**MUNICIPAL PLANNING COMMISSION
REGULAR SESSION AGENDA
August 26, 2026, 6:00 pm
Red Bank Court Room
3117 Dayton Boulevard**

Planning Commission Regular Session 8-26-2026

Request: Design Review for 3415 and 3423 Dayton Boulevard

DESIGN REVIEW STANDARDS CHECKLIST: 3415 Dayton Boulevard (2026-08-10)

REVISED PLAT- LOTS 1-4

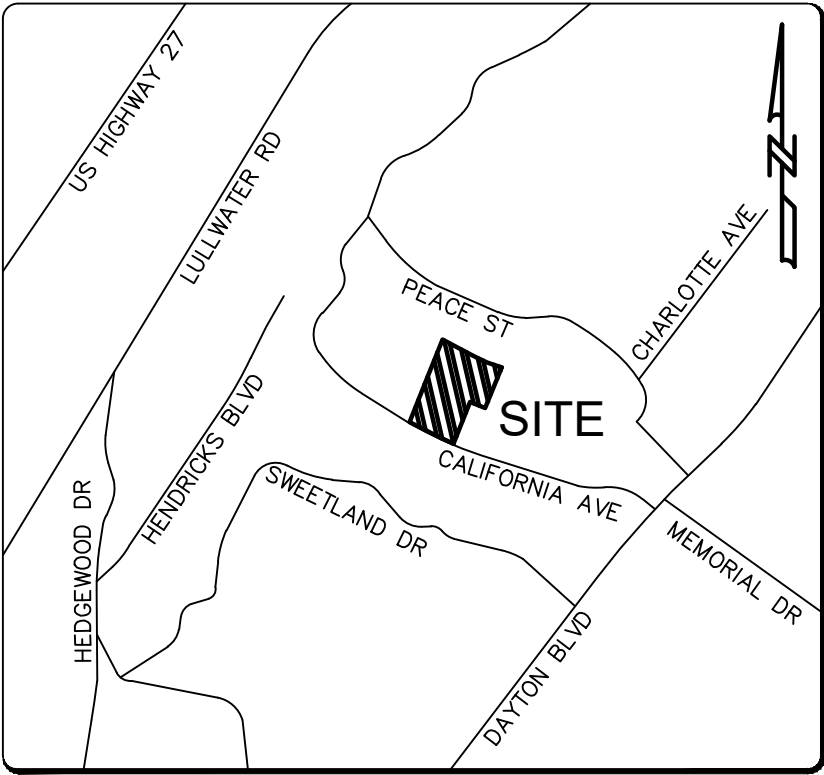
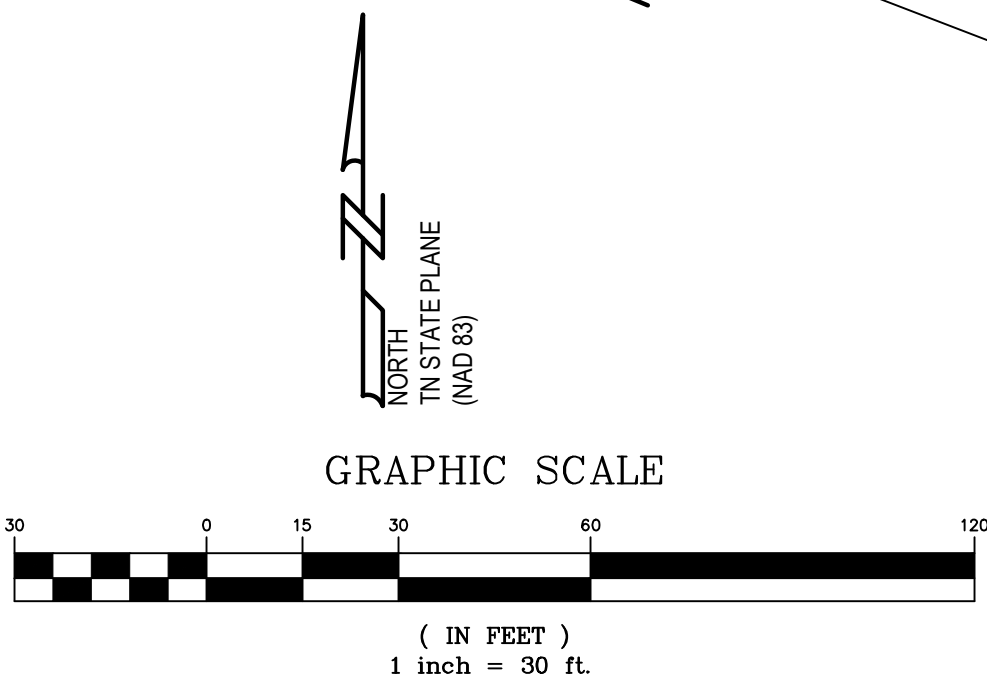
The purpose of the ordinance is to promote more predictable and prudent development decisions in line with emerging developmental goals for the city. The plat aligns with the site plan the applicant submitted for the rezoning to R-T/Z in June 2026 and no changes in lot dimensions have changed. The proposed subdivision and resulting flag lot meet the requirements of the flag lot ordinance established in 2017 and therefore staff recommend approval of the plat.

FINAL PLAT

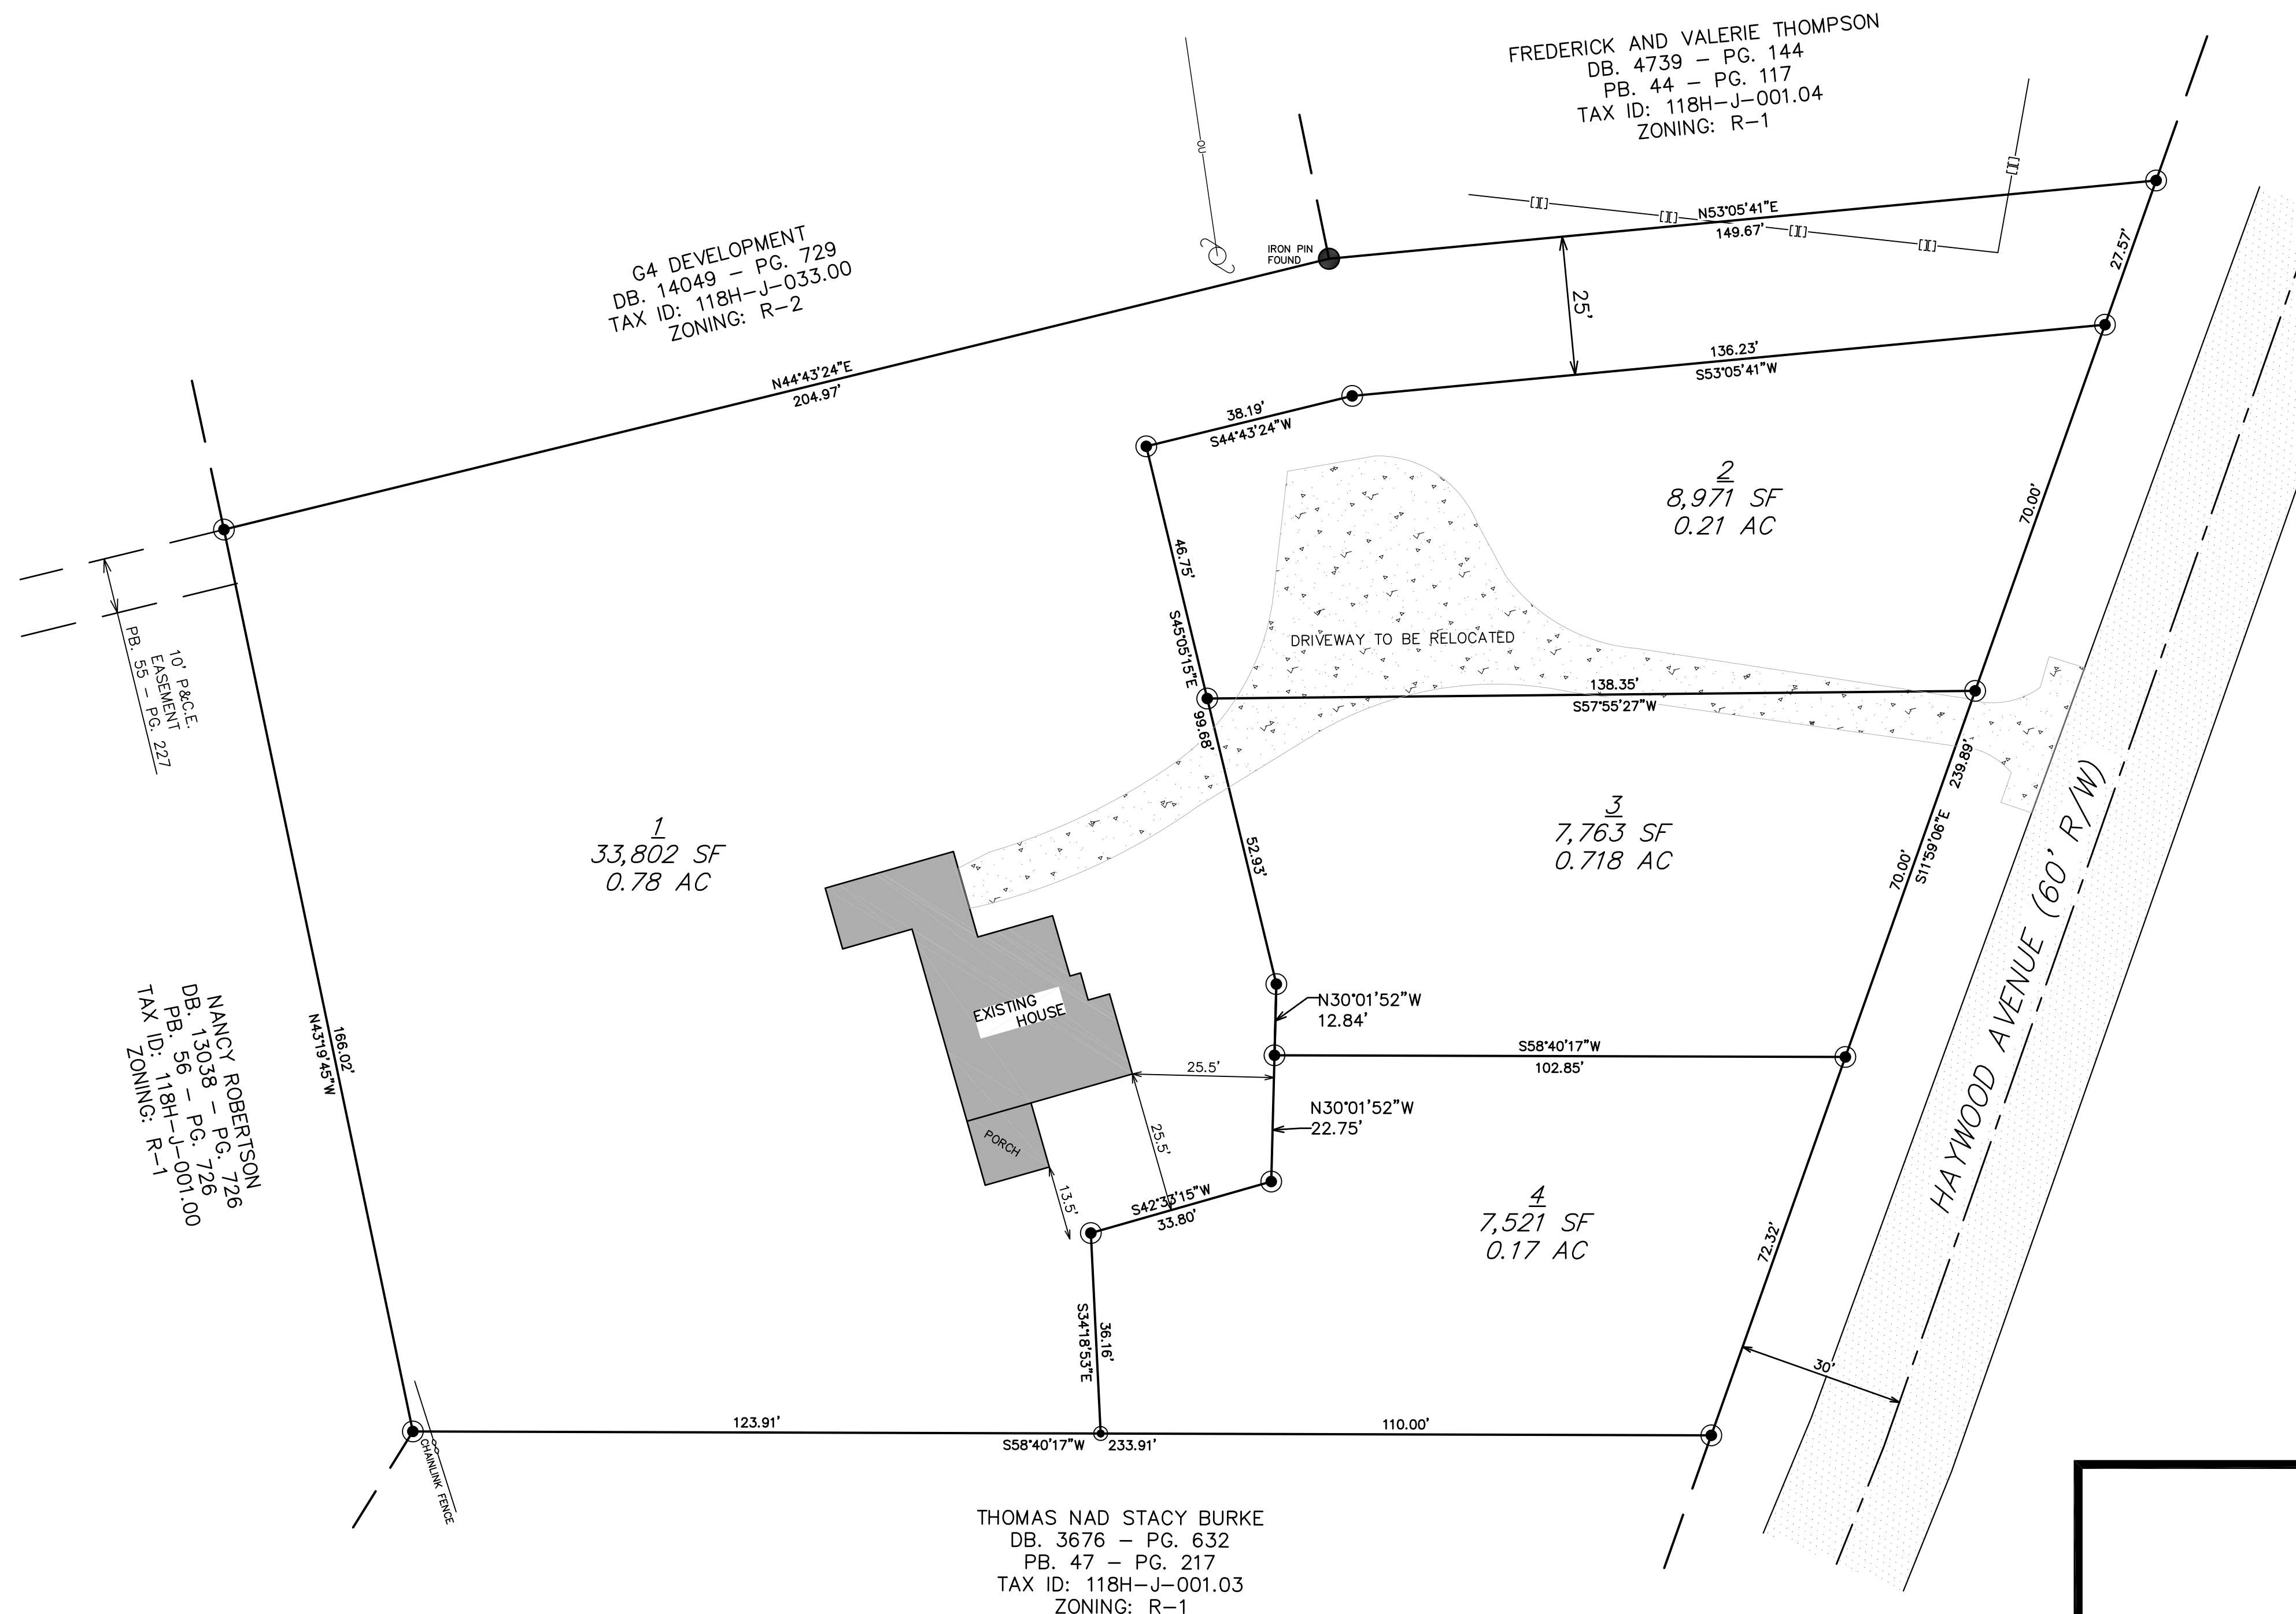
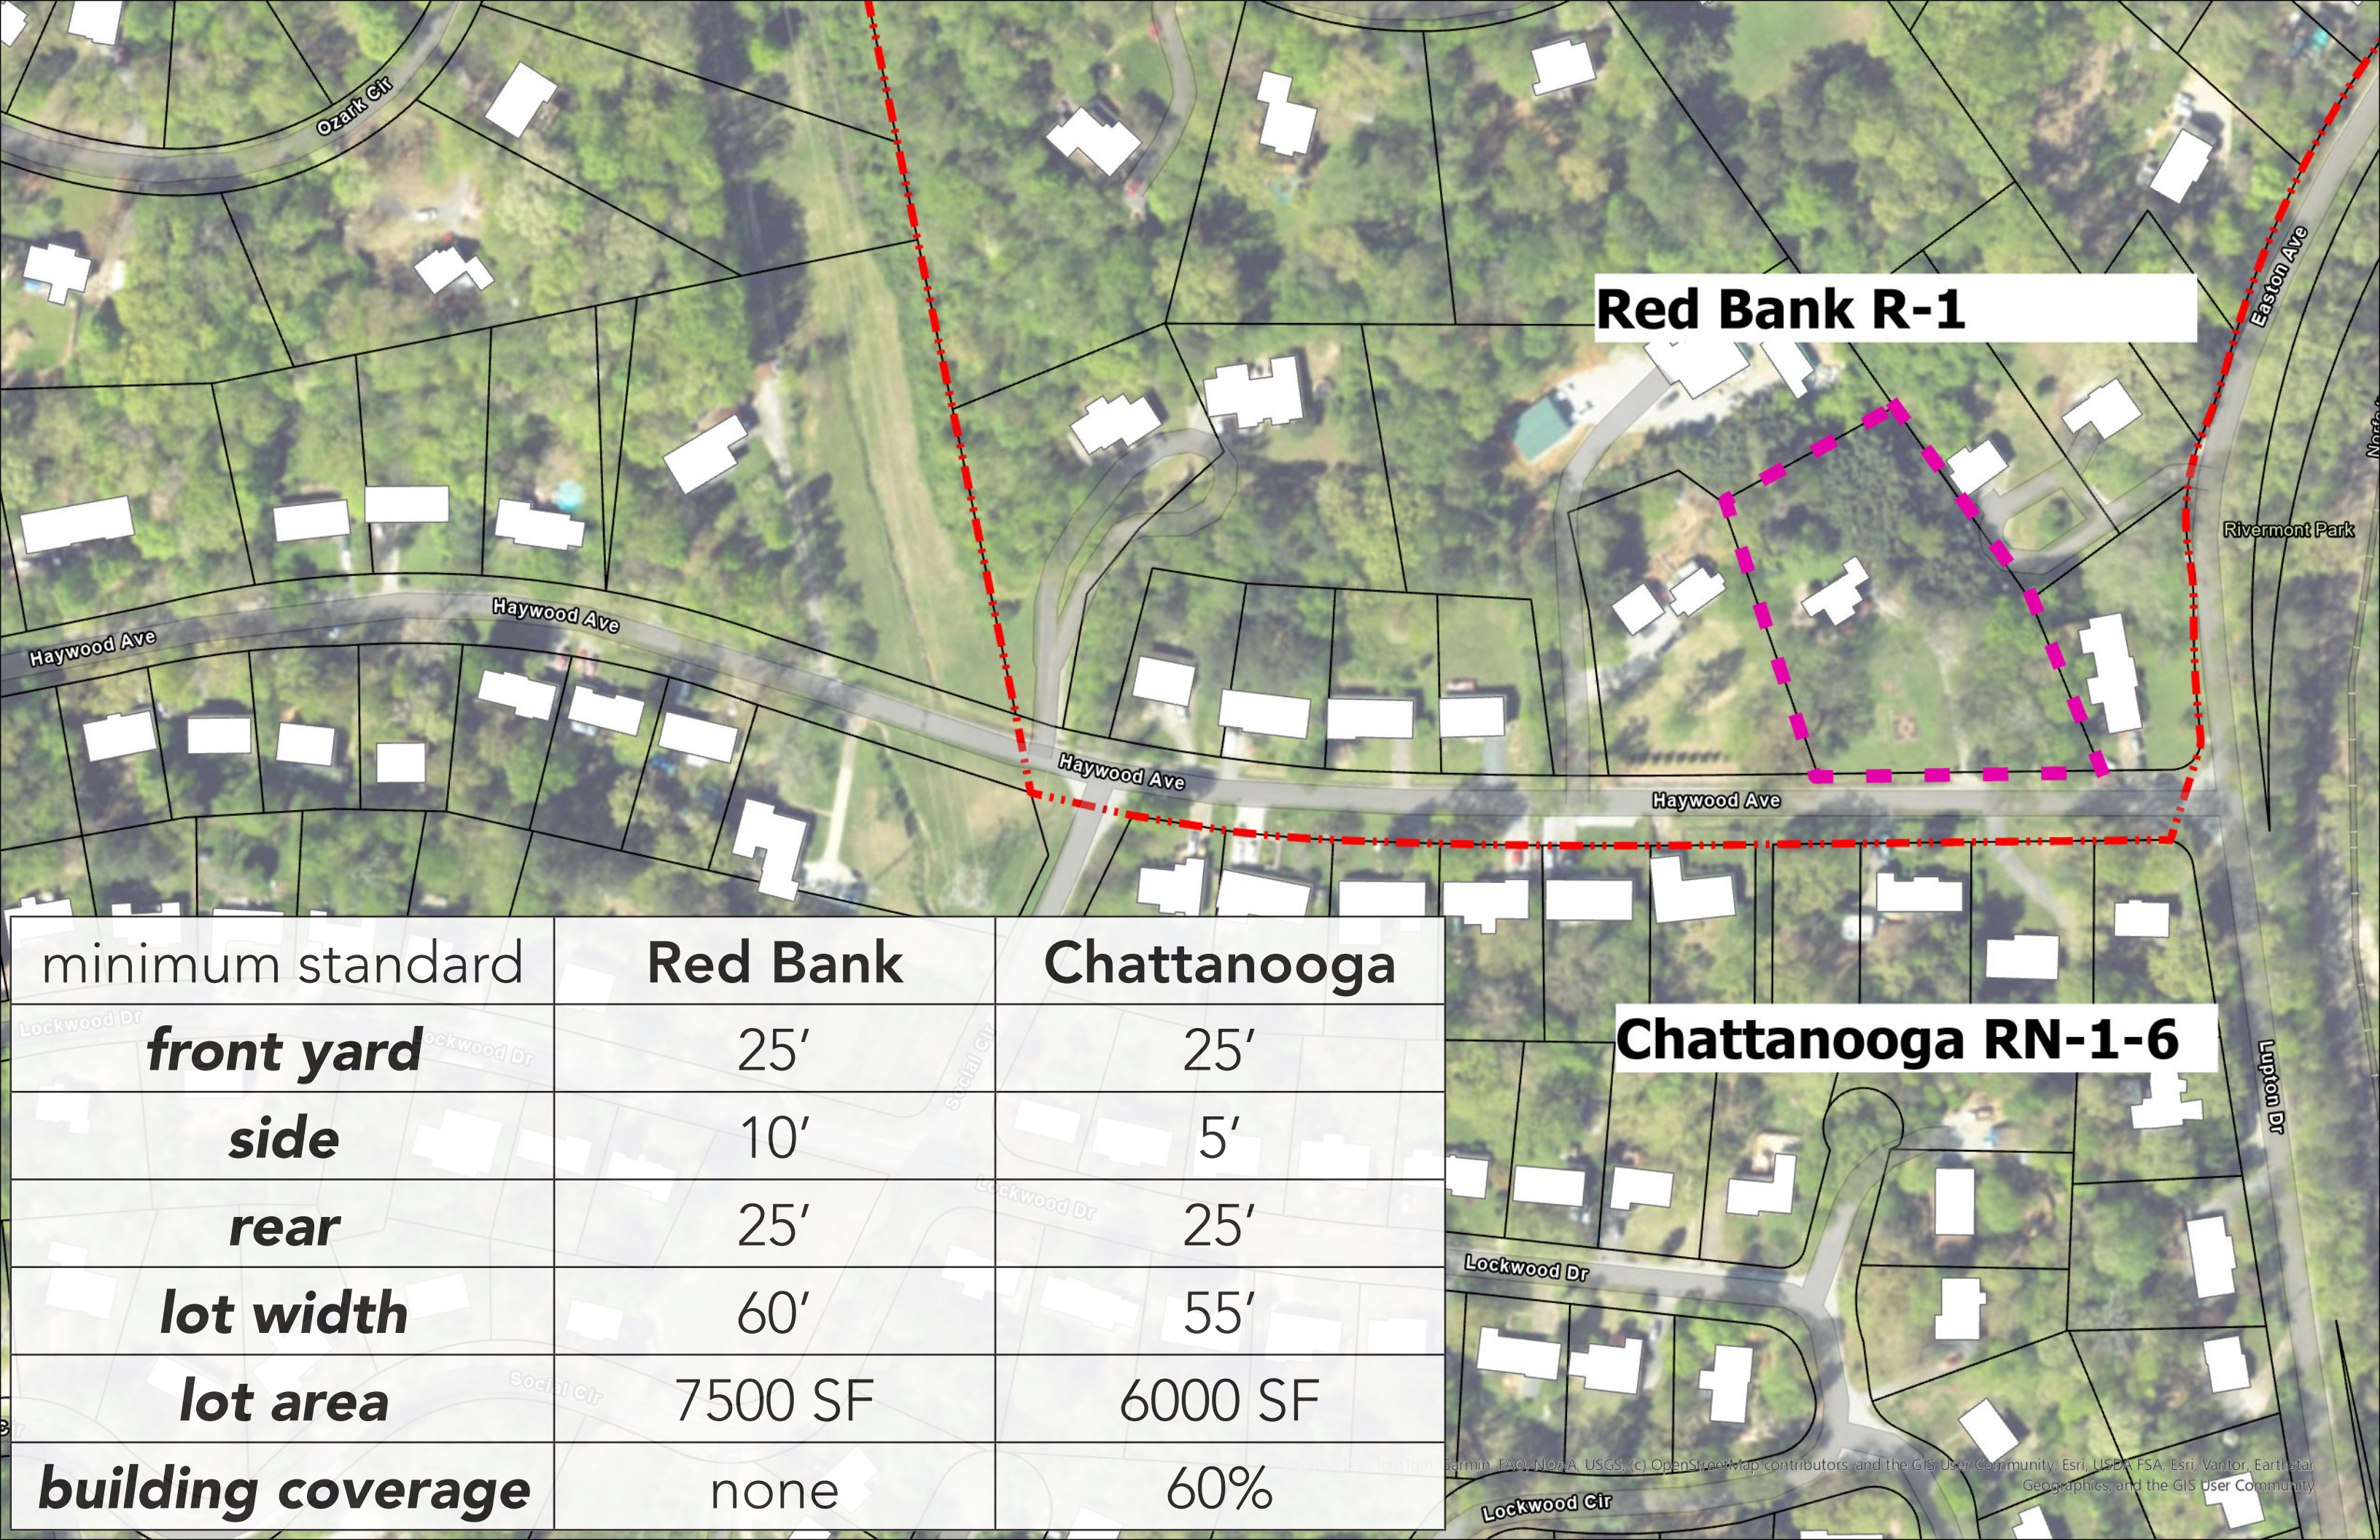
The purpose of the ordinance is to promote more predictable and prudent development decisions in line with emerging developmental goals for the city. The plat and resulting flag lot meet the requirements of the flag lot ordinance established in 2017 and the development standards of the R-1 zone. Therefore staff recommend approval of the plat. Because the property lies in the sphere of influence of the City of Chattanooga, it may be helpful to understand the development standards comparison:
